MEMORANDUM

To: Salt Lake City Historic Landmark Commission
From: Kelsey Lindquist (385) 226-7227
Date: November 25, 2020
Re: 4th Avenue Pump House New Construction Modification

This memorandum provides updated information on the approved 4th Avenue Pump House new construction, petition number PLNHLC2018-00557. Since the approval in May of 2020, Salt Lake City Public Utilities has engaged with Rocky Mountain Power on the approved building and associated electrical equipment. In order to provide service to the site, Rocky Mountain Power is updating the electrical equipment previously reviewed by the Historic Landmark Commission which consists of a modification to the approved equipment. In addition to the approved transformer, the following equipment is being requested as part of this modification to the approval:

Approved Electrical Equipment

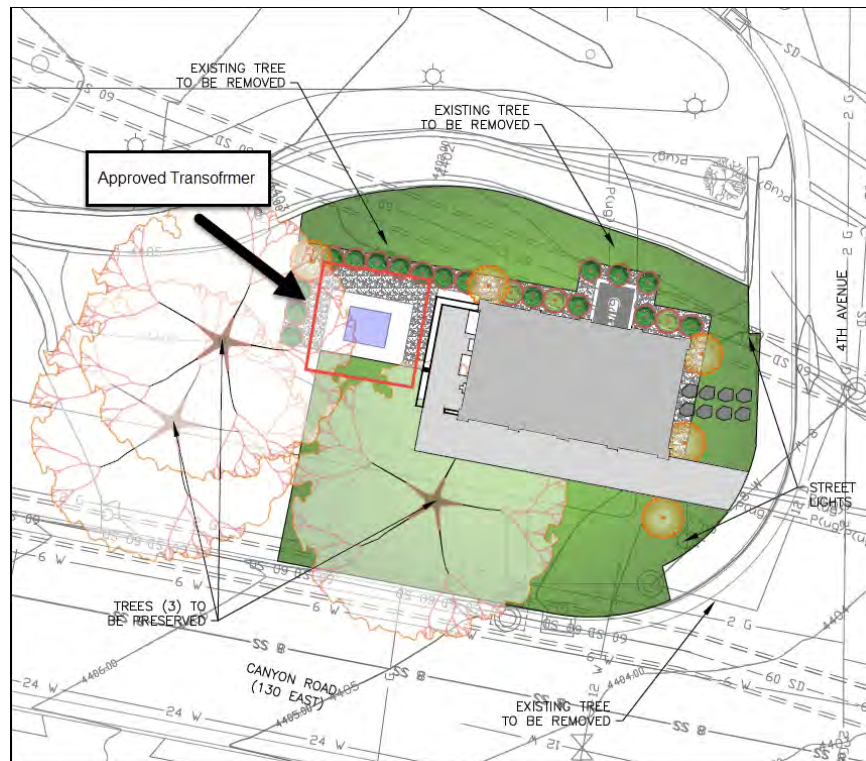
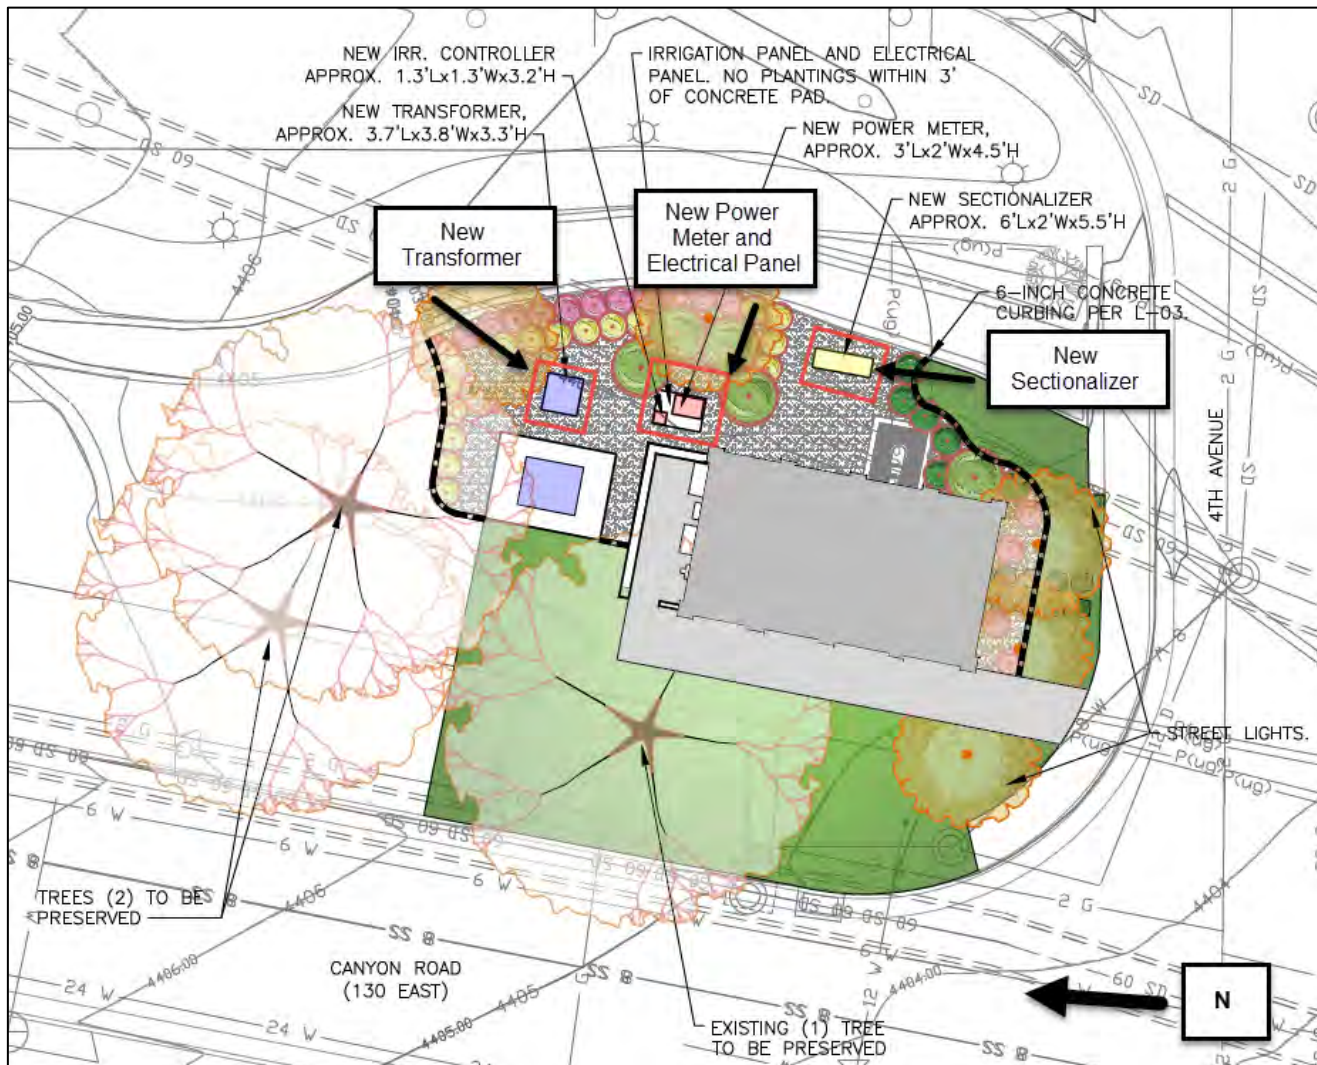
Since the approval in May of 2020, Salt Lake Public Utilities has engaged with Rocky Mountain Power (RMP) on the approved building and associated electrical equipment. **Per the applicant's statement:** during site visits and investigations with RMP, it was determined that there was another separate power meter on-site (supplying power to the existing park lights and irrigation timer). RMP also determined that the existing high voltage buried primary power conductor was not long enough to extend from the existing transformer to the proposed new well transformer to the north. Based on the second meter and conductor length, RMP will need a change in the approved electrical equipment to include a sectionalizer, also known as a ground sleeve, to be installed on the site. A sectionalizer is an above ground utility box approximately 6-feet long, 2-feet wide and 5.5-foot tall and green in color. Photos of existing sectionalizers in Salt Lake City are included in Attachment C.

The location of the approved pump house is quite restrictive with the faux City Creek stream, which functions as **a storm channel, to the east, and a 39" caliber London Plane tree to the west.** According to the applicant, the least intrusive location of the proposed sectionalizer is west of the storm water channel and east of the east elevation of the approved pump house.

Approved Landscaping

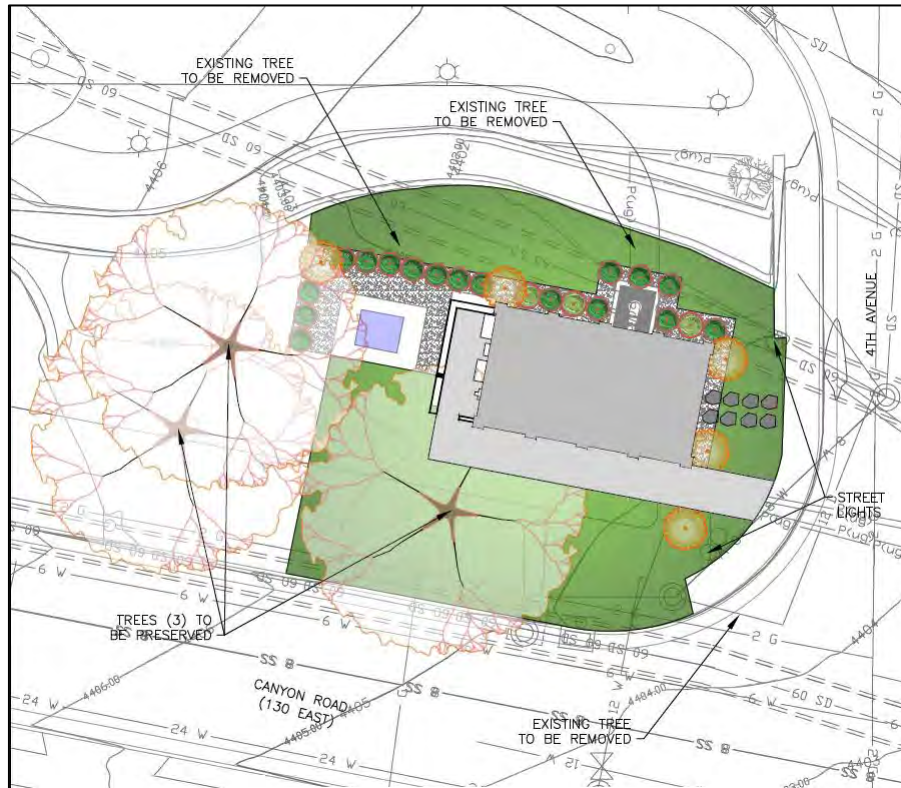
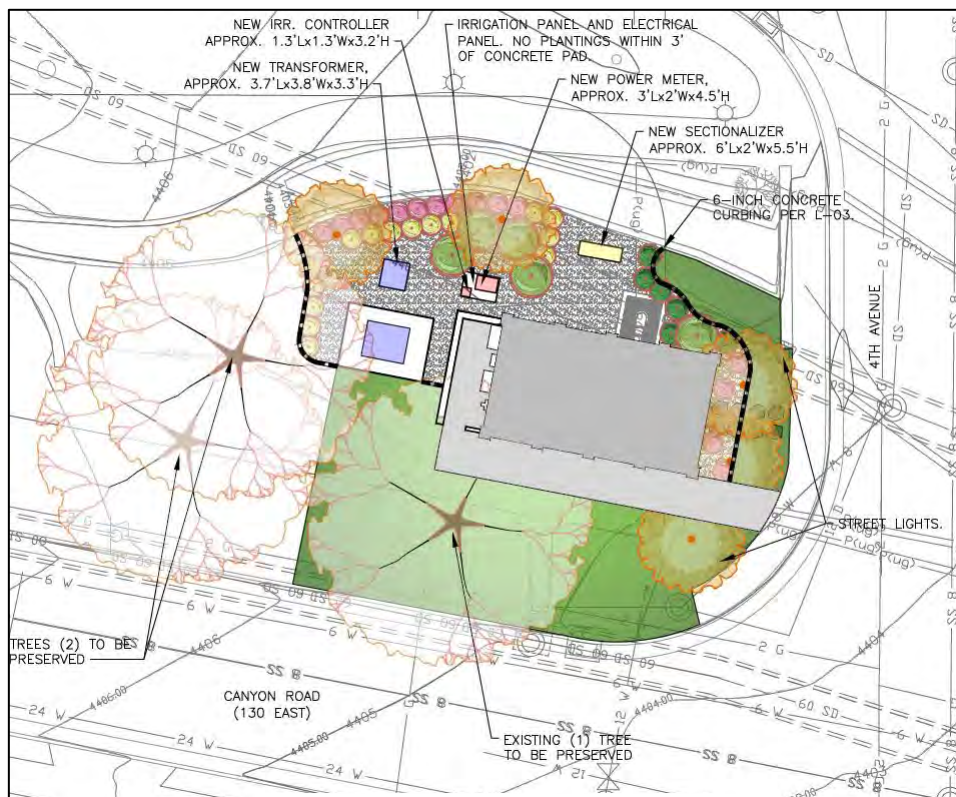
In addition to the sectionalizer, RMP will need an additional transformer and a new power meter enclosure for the park lights and irrigation. The new transformer is approximately 3.7-feet long, 3.8-feet wide, and 3.3-feet tall and is proposed to be located above ground to the north east side of the new pump house building, as shown on the revised site plan above. The new power meter enclosure is proposed to be located north east of the approved pump house and will be approximately 3-feet long, 2-feet wide and 4.5-feet tall. The proposed location of the additional electrical equipment will be visibly reduced by the scale of the recently approved pump house and are

located to minimize impacting the trees that are intended to be preserved. To further reduce the visual impact, additional landscaping is proposed to be located around the new electrical equipment. The new landscaping proposal includes 2 new trees, 4 new shrubs and 31 new low-profile hedges. The full revised landscaping proposal is illustrated below and in the attachments.

UPDATED DESIGN FOR ELECTRICAL EQUIPMENT CHANGES

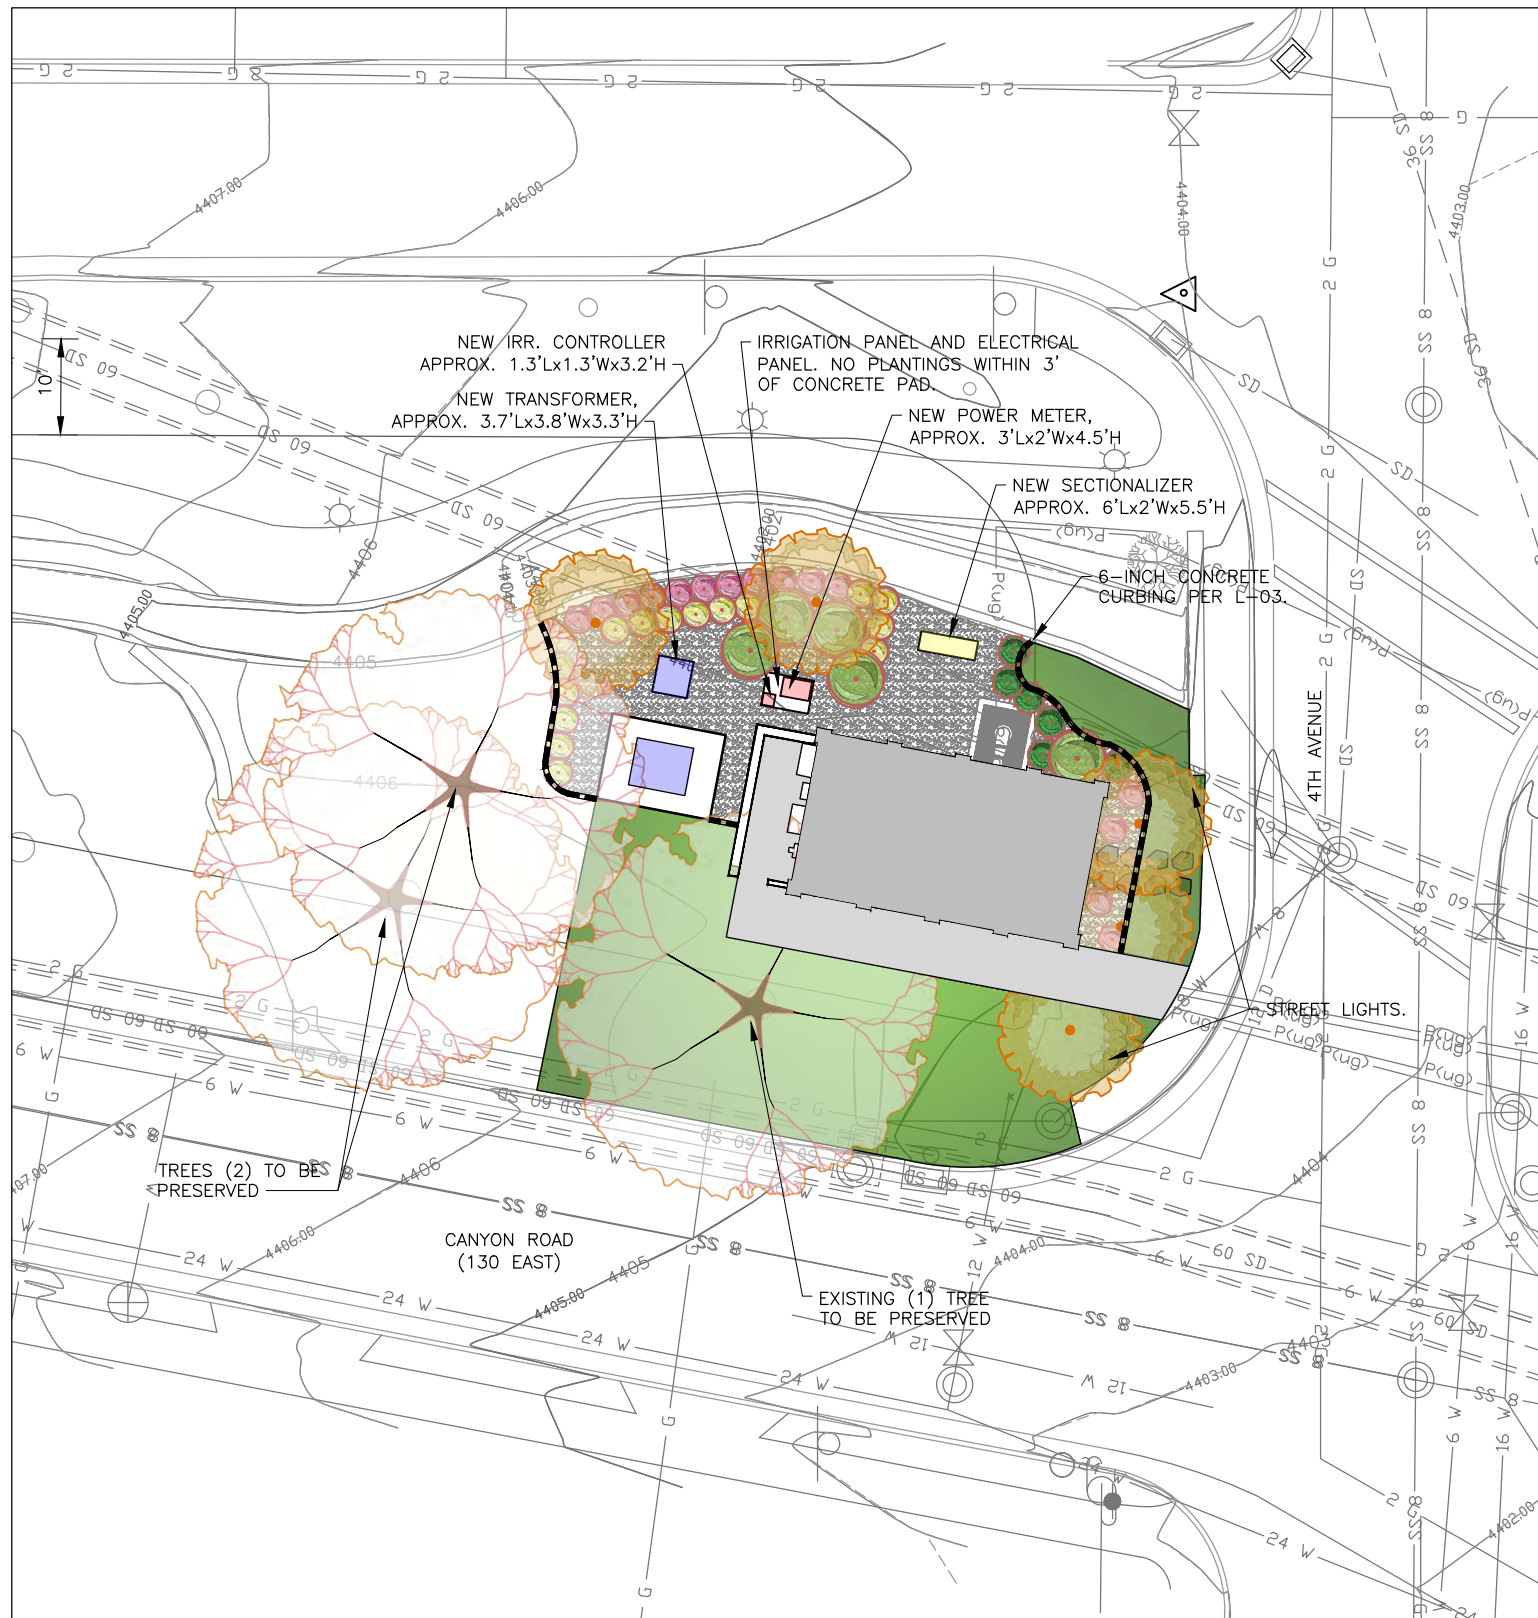
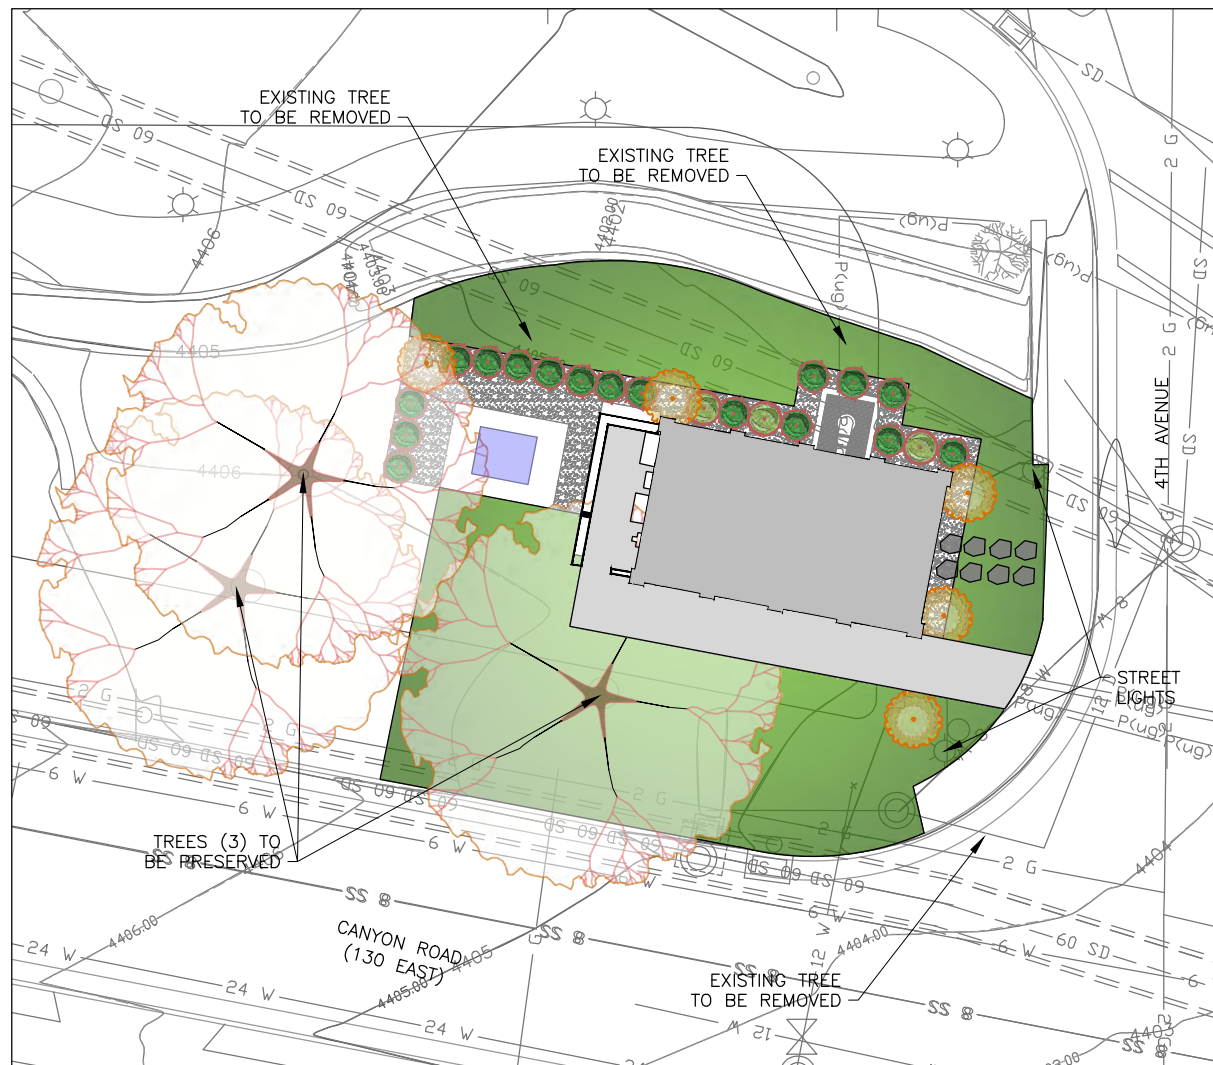
Due to those items, RMP will require a sectionalizer (also known as a ground sleeve) and an additional transformer (single-phase) that were not included in the site plans previously submitted to HLC. In addition, a new power meter enclosure for the park lights and irrigation controller will be relocated from above the existing underground vault to the east side of the building as shown in the updated site plans.

The site plan previously submitted to HLC included a new 3-phase power transformer on the north side of the well building. Plans for that transformer have not changed; it will supply the power to the new well building. The new single-phase transformer is needed to re-supply/provide power to the park (lighting and irrigation). The new single-phase transformer will be approximately 3.7-feet long, 3.8-feet wide, and 3.3-feet tall. It will be mounted above ground and located on the north side of the building, situated east of the 3-phase transformer, as shown in the updated site plans with the required RMP clearances. Its view will be obstructed from the south by the well building and the existing rock wall over the creek channel, from the west by the larger well transformer, and from the north and east by the landscaping. The landscaping plans were updated to account for the new electrical equipment and are attached.

RMP gave three options regarding adding a sectionalizer. The first option was to place the sectionalizer on the west side of the stream channel (where it is shown on the updated plans). This option would allow the existing buried high voltage conductor (that currently serves the existing transformer) to be excavated and exposed from the sectionalizer's proposed location to the existing transformer. Then that exposed wire would be rolled back into the sectionalizer to be re-used (since extending the conductor without a sectionalizer is not per code). In order to locate the sectionalizer on the west side of the stream channel, its location must be exactly as shown on the site plans on the east side of the well building. The proposed location is dictated by the needed length of existing buried power wire to reuse and to obtain the necessary safety clearances that RMP requires for the sectionalizer enclosure. The limited space between the open stream channel and the buried 60-inch storm drain line is also a constraint.

The sectionalizer, as proposed in the attached site plans and described above under option 1, will be obstructed from the west by the well building, nearly completely obstructed from a southern view by the existing rock wall over the stream channel, landscaping, and the well building, and a nearly completely obstructed view from the north by landscaping. The view from the east will be the most exposed due to the necessary clearances that RMP requires around the enclosure. Fortunately, the 5.5-foot tall sectionalizer will be backdropped by the larger 13-foot tall well building. The rendering of the site view, previously submitted to the HLC, that was impacted by the new required electrical equipment has been updated; in addition, a new view looking at the well building from the east was created.
